**CITY OF PORTLAND, MAINE  
DEVELOPMENT REVIEW APPLICATION  
PLANNING DEPARTMENT PROCESSING FORM  
Planning Copy**

**Nissen Office Compled - Change of Us**  
Project Name/Description

RE: Change of Use, Vicinity of 59 Washington Street

**TO:** Jonathan Spence - Planner  
**FROM:** Jim Seymour  
Development Review Coordinator, Sebago Technics, Inc.  
**RE:** A & M Partners, LLC-Former Nissen Bakery Parking Renovation  
**DATE:** September 3, 2002

FLOOR PLAN - LEVEL 3  
Scale: 1/16"=1'-0"

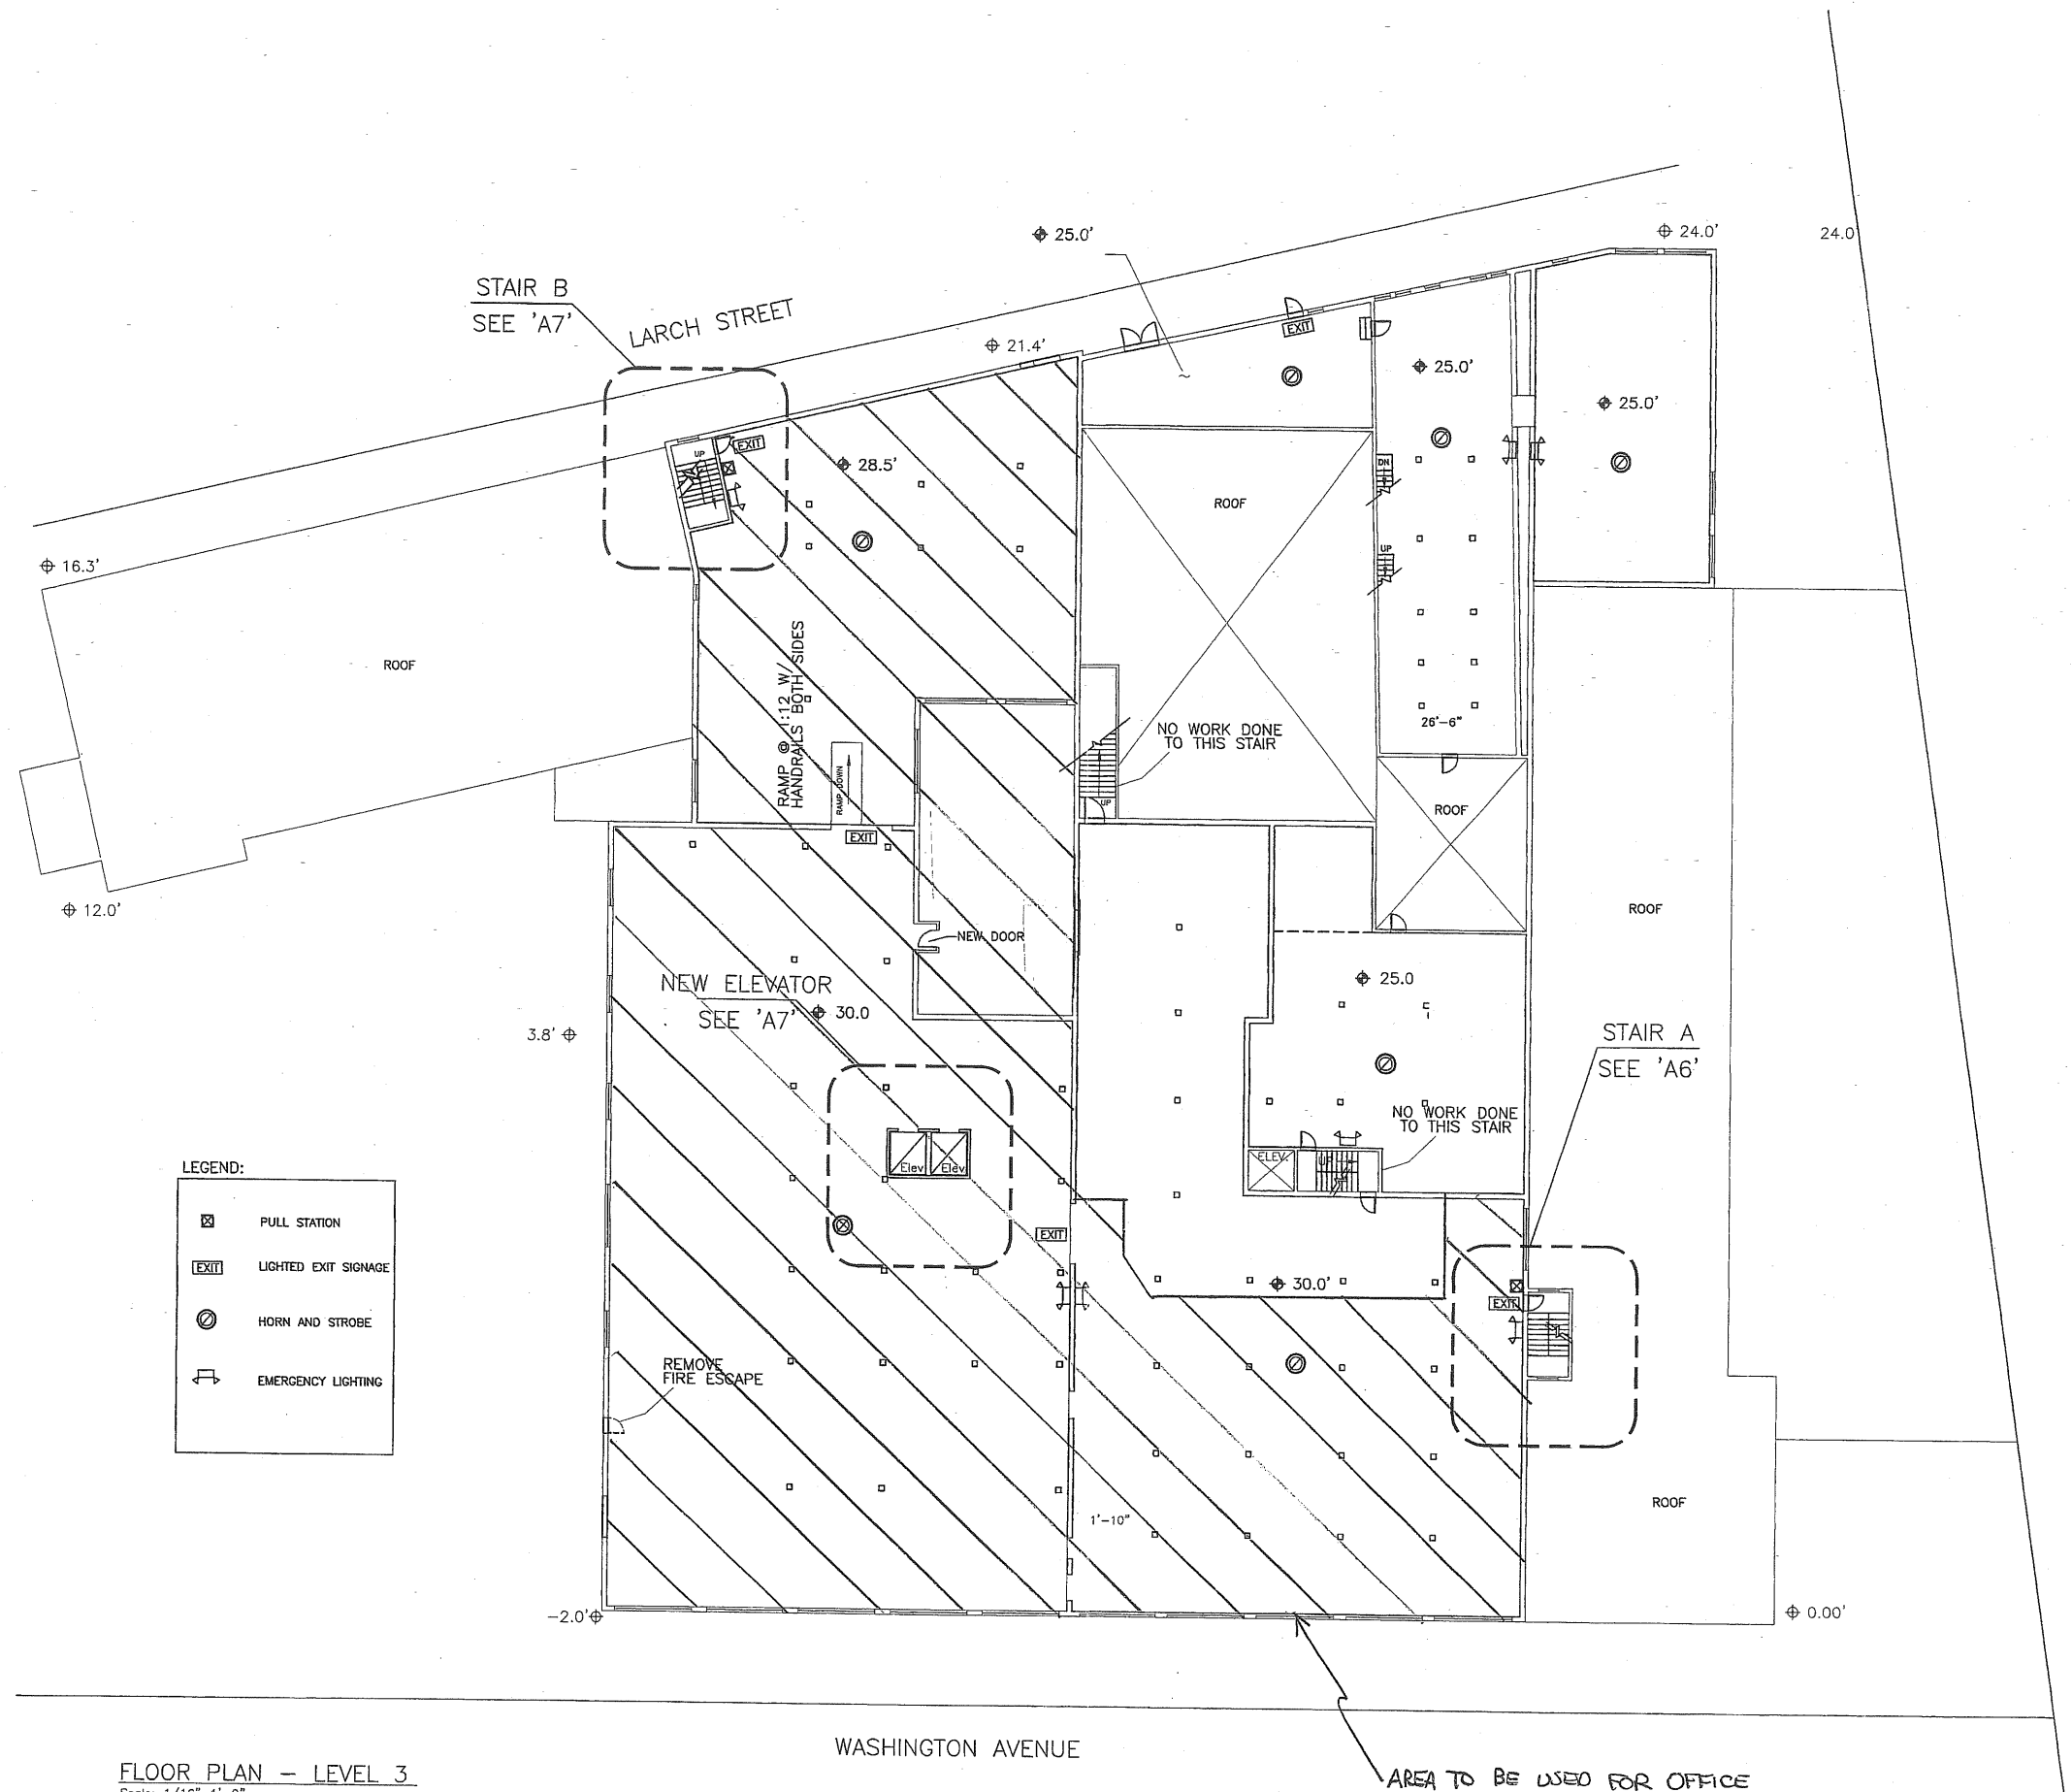
I have been given the 3rd floor change of use information for the Casey Family Group.

The entire office build out for this tenant is 25,203 sq. ft. 16,850 sq. ft is existing office and 8,353 sq. ft. is the change of use. The amount of parking required for this area is:

I believe that the new revised parking lot show 66 spaces. I understand that there are some other parking lots that are also part of this complex.

Any future change of uses and tenant fit-up will need to show us their entire parking plan.
